**AIRWORTHINESS
DIRECTIVE**

NUMBER:
02 / 09

AFFECTED PRODUCTS: Amateur built aircraft (Order 31 May 1982, BOE 5 June) constructed from kits PEGASUS QUIK all versions, and any other aeroplane (home built or Type Certificate) fitted with CKT stainless steel twin exhausts, which have serial numbers 8230 to 8430.

SERVICE BULLETIN NUMBER 127
including
MODIFICATION M228

Fig 1. Crack location all round weld outer edge

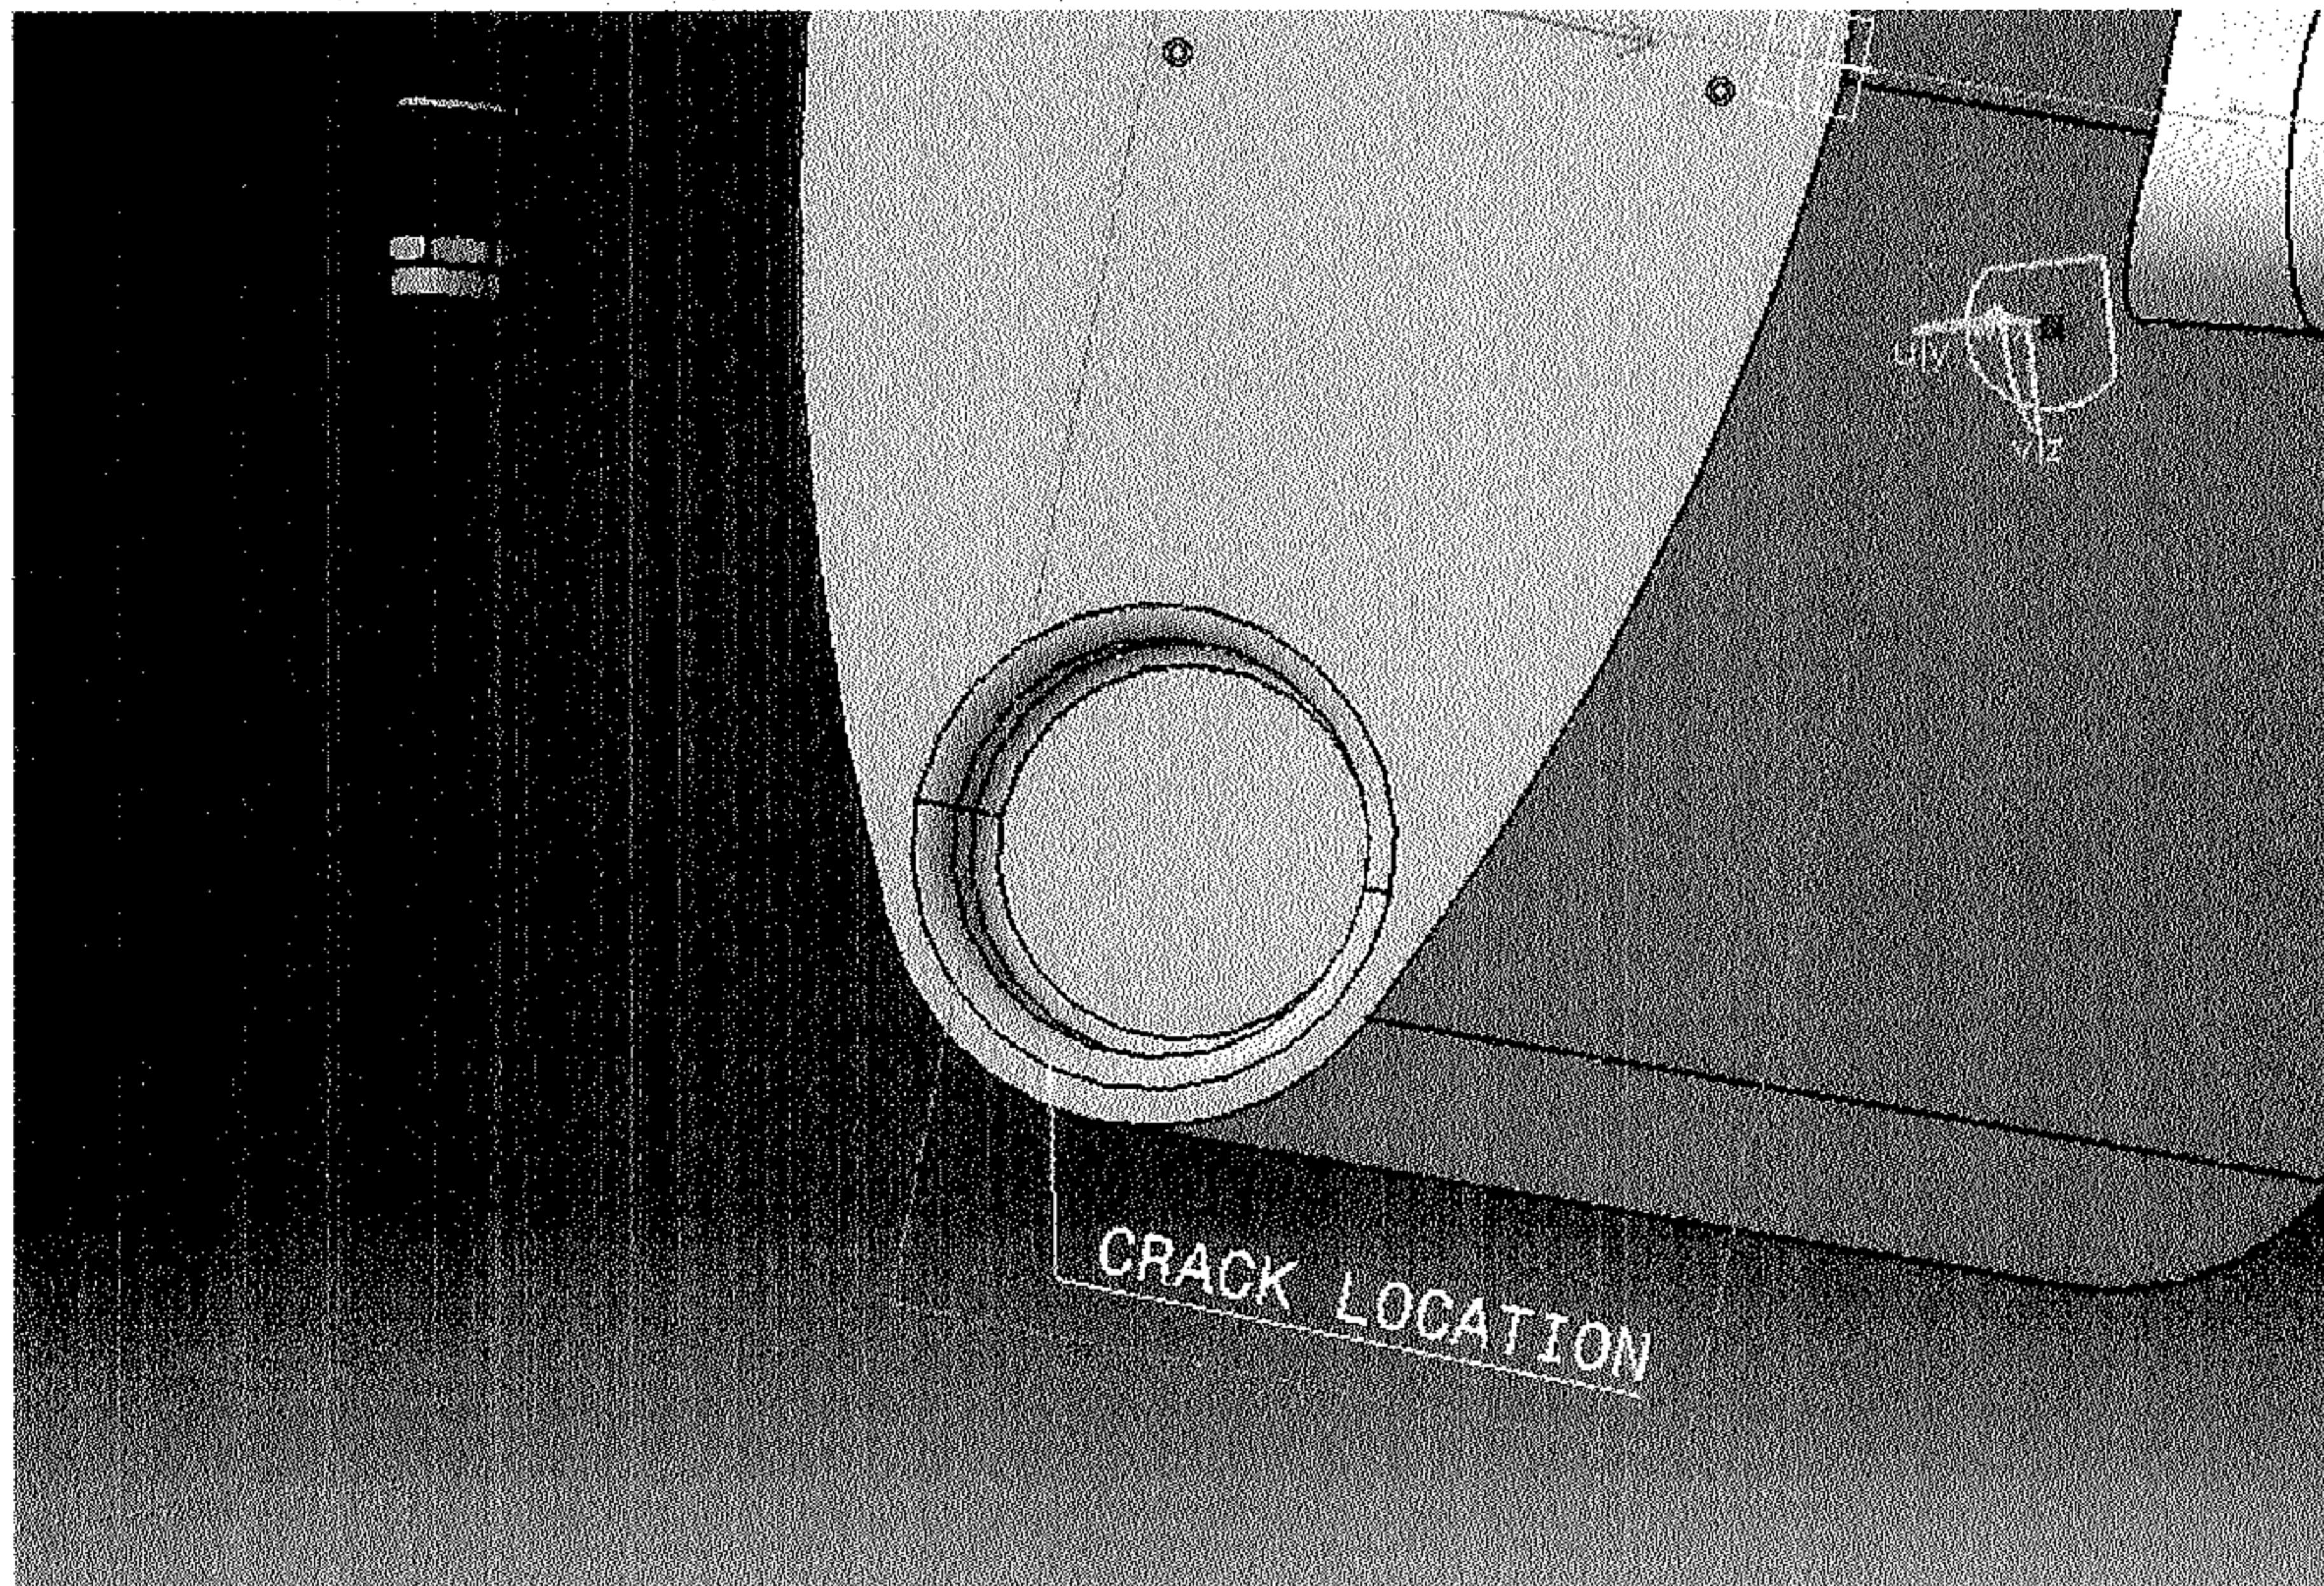
The CKT exhaust silencer has separate front and rear perforated baffle tubes which are welded to the front and rear end cap flanges and plugged with a cap. A fatigue failure of a pair of exhausts serial no. 7811107 has occurred at 125 hours, around the flange edge on the rear end cap, at the weld edge (see fig 1). The baffle tube came free and was ejected from the silencer and hit the propeller. Fortunately this happened at low power on approach, propeller damage was localised and the baffle tube missed the sail; under high power the consequences could be very serious.

Before further flight, using good light and a magnifying glass, closely inspect the area around all 4 silencer end caps for cracks, particularly on the weld edges (see fig 1). If cracks are noted, contact P&M Aviation, if possible by email attaching pictures of the damage, hours run, aircraft and exhaust serial numbers. The aircraft must not be flown with cracks in this area.

Fig 2. Movement of inner baffle plate.

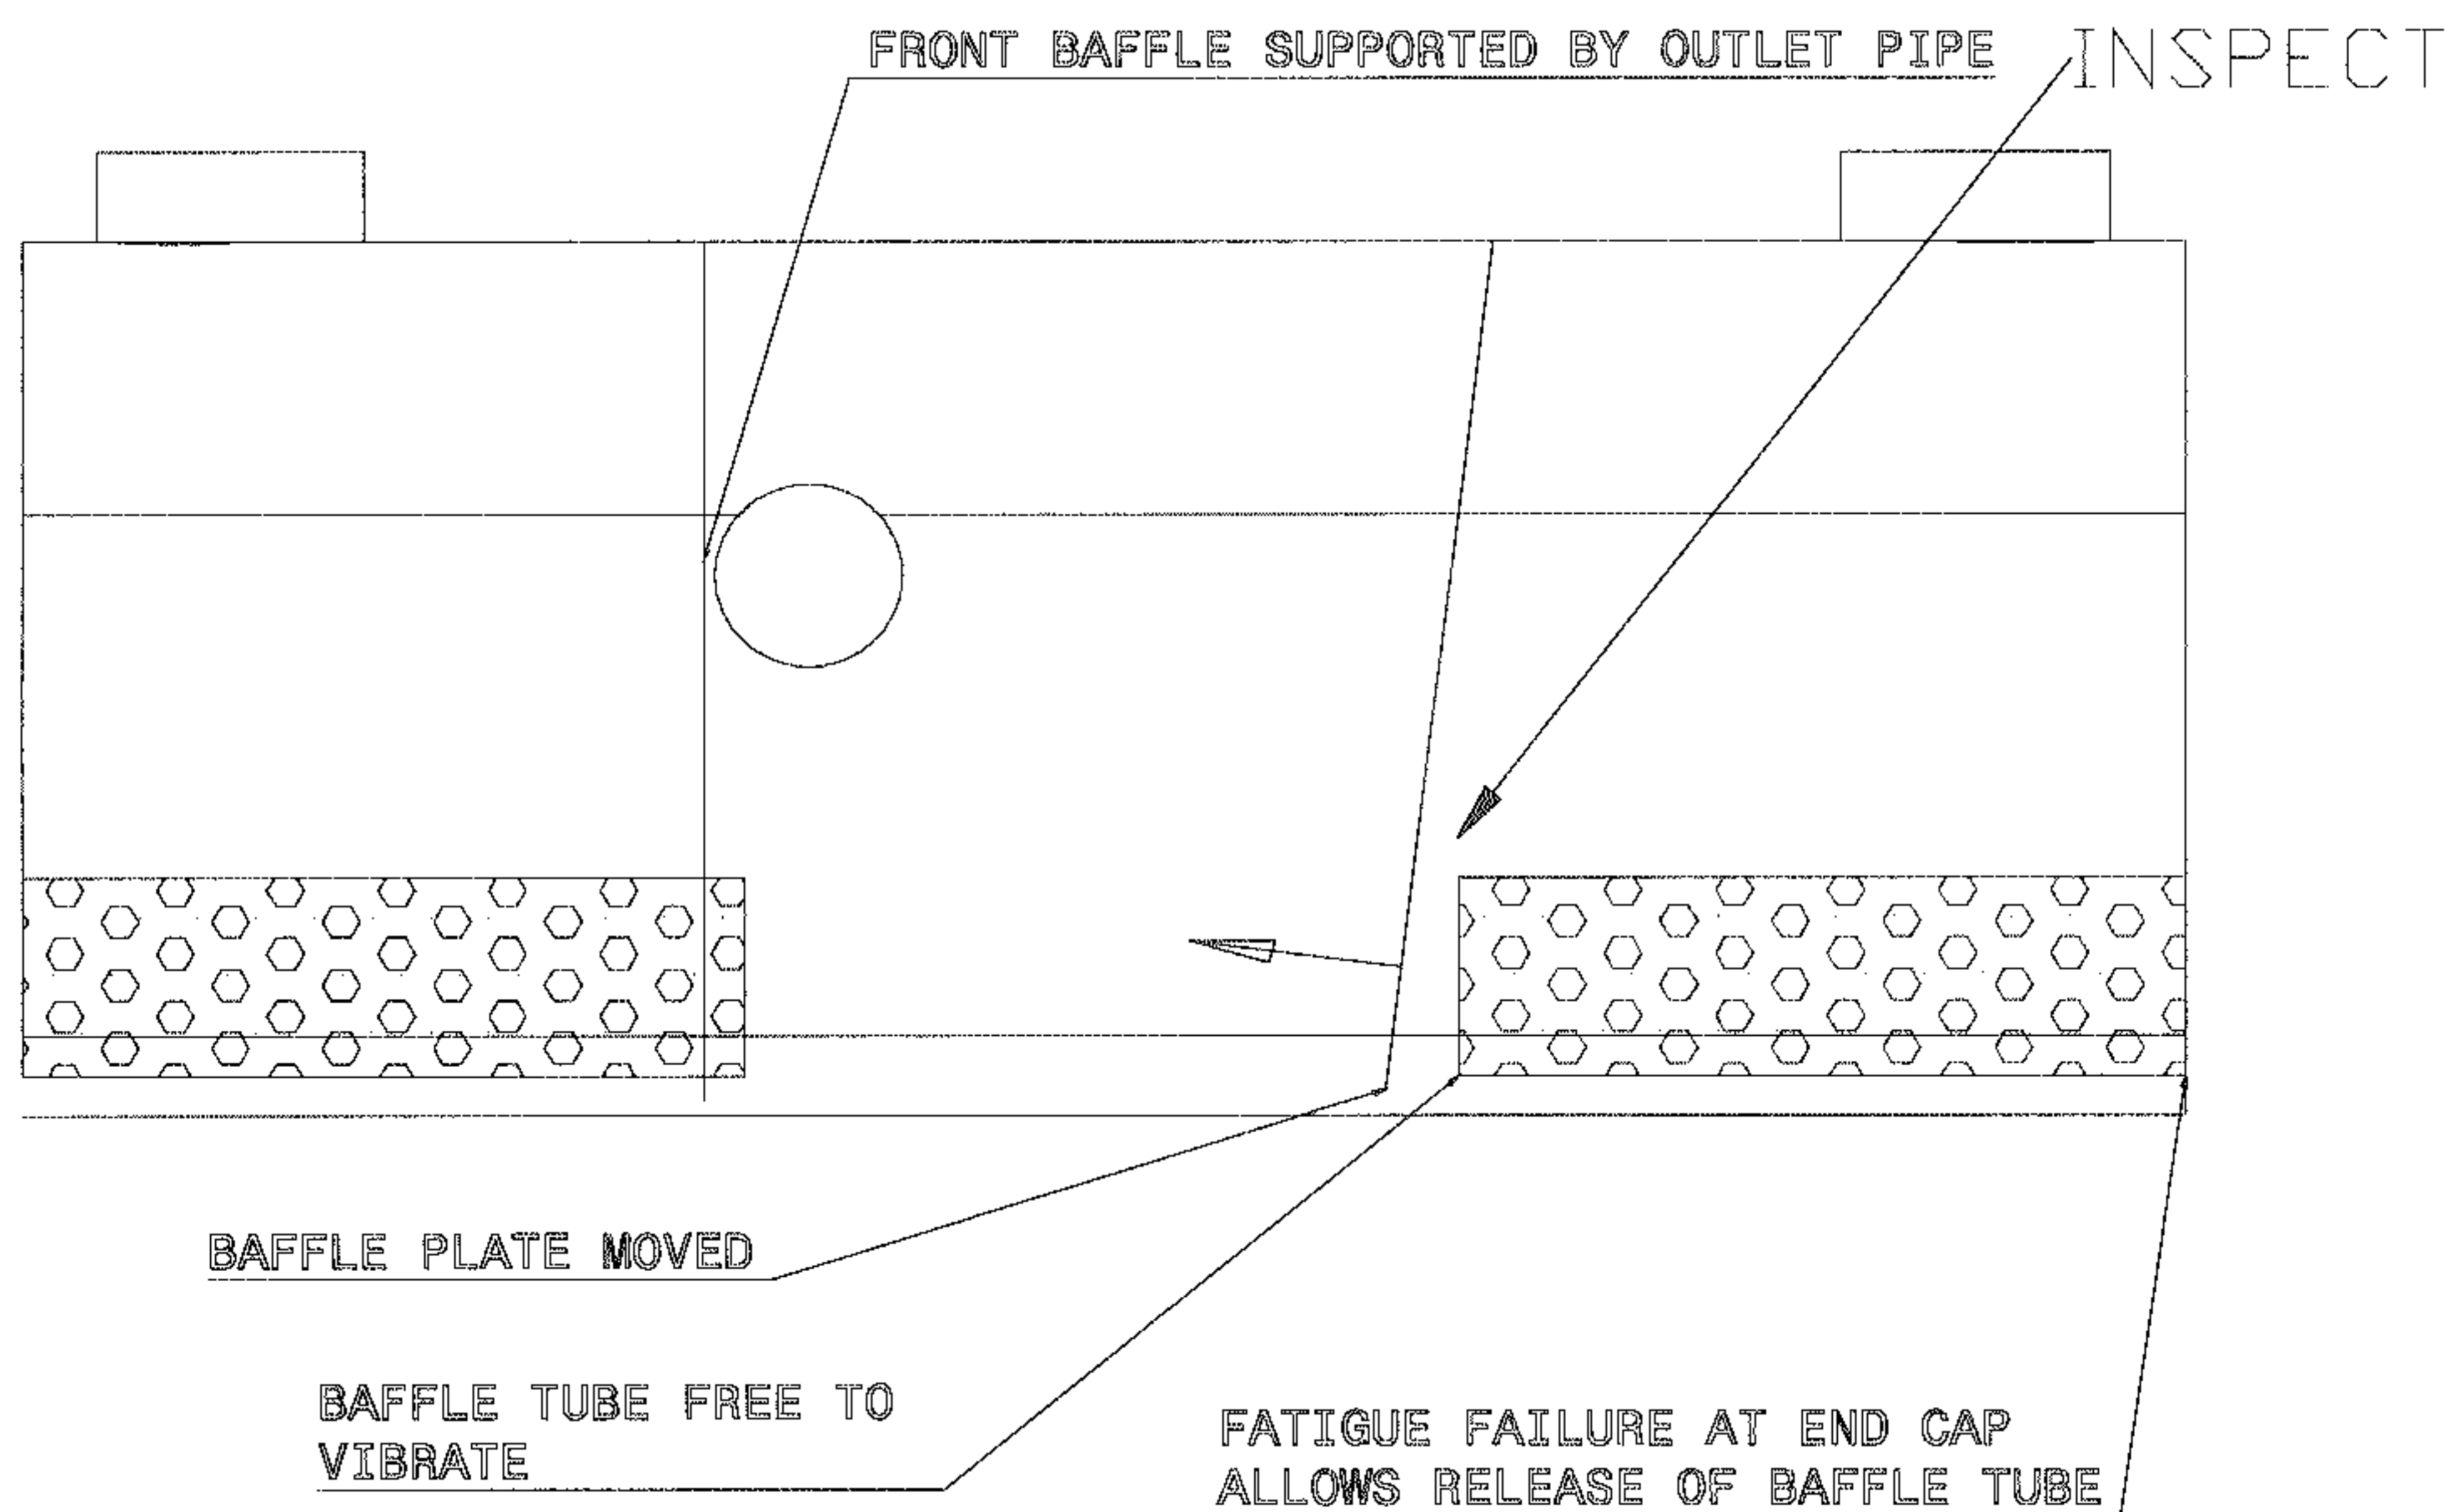
See fig. 2. Through the exhaust header pipe holes, using a torch and mirror, inspect the welded connection between the internal baffle plate and the end of the perforated baffle tube. Try pushing the bottom of the internal baffle plate inwards. If the baffle plate has moved inwards towards the centre of the exhaust and the baffle tube

has disengaged from the baffle plate, *the exhaust must be replaced*. Disengagement is more likely on the rear internal baffle, as the front internal baffle is supported by the outlet pipe.
